Med Park 15 – Replace AHU-1 & 2

Addendum Two

December 6, 2019

DEMO AND RENO FLOOR PLAN.

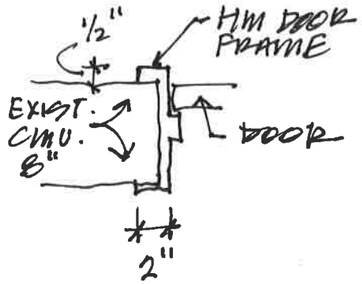
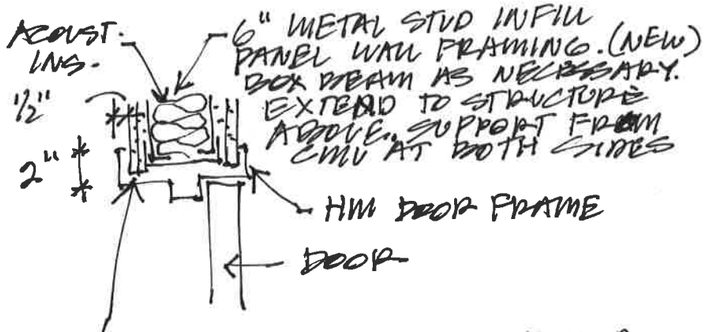
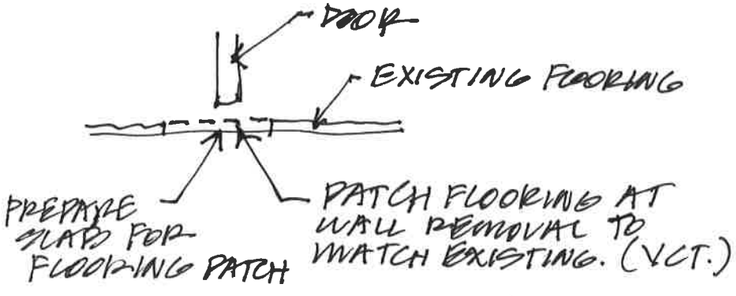
1. Add double door to new mechanical room based on attached sketch.
2. Drawing M1.0 – Make changes to drawing as indicated in attached.
3. Drawing M2.0 – Return ductwork is below slab. Unit shall have enough height (unit plus housekeeping pad) for a deep seal p-trap to be installed and spill into condensate pump.
4. Drawing M2.0 – Make changes to drawing as indicated in attached.
5. Drawing E3.0 - Make the following revisions to the drawing:
    a. Relocate existing light switch within new mechanical room to accommodate new double door as shown in architectural sketch. Surface mount switch and modify/extend conduit and wiring as required.

(1) REMOVE EXISTING HM FRAME AND WOOD DOOR COMPLETELY. REMOVE ALL ASSOCIATED HARDWARE AND ATTACHMENTS.

(2) SAWCUT SECTION OF EXISTING 8" CMU WALL AND REMOVE, FROM JAMB SIDE OF EXISTING DOOR AND EXTENDING TO ROUGH OPENING SIZE AS NEEDED FOR NEW DOOR AND FRAME INSTALLATION. REMOVE CMU FROM FLOOR TO UNDERSIDE OF STRUCTURE. GRIND REINFORCEMENT FLUSH WITH SLAB.

(3) REMOVE AS MUCH CEILING ON EACH SIDE OF WALL AS NECESSARY FOR WALL WORK. SALVAGE FOR REUSE.

[1] INSTALL NEW HM FRAME AND DOOR.

FRAME: -2" JAMBS - 1 HR. RATED
-2" HEAD
-18 GA.
-PRIMED FOR FIELD PAINT
-SEE HEAD, JAMB, SILL DETAIL

DOOR: -18 GA. HM. -1.75" THICK
-HOLLOW CORE.
-1 HR. RATED
-7'-0" X 6'-0" PAIR

HARDWARE:
-GRADE 1 -CYLINDRICAL LEVER-SET STORAGE FUNCTION
-ANSI A115.1
-6 HINGES
-2 CLOSERS -SILENCERS
-1 SET MAN. FLUSH BOLTS
-DUST PROOF FLOOR STRIKE
-ASTRAGAL
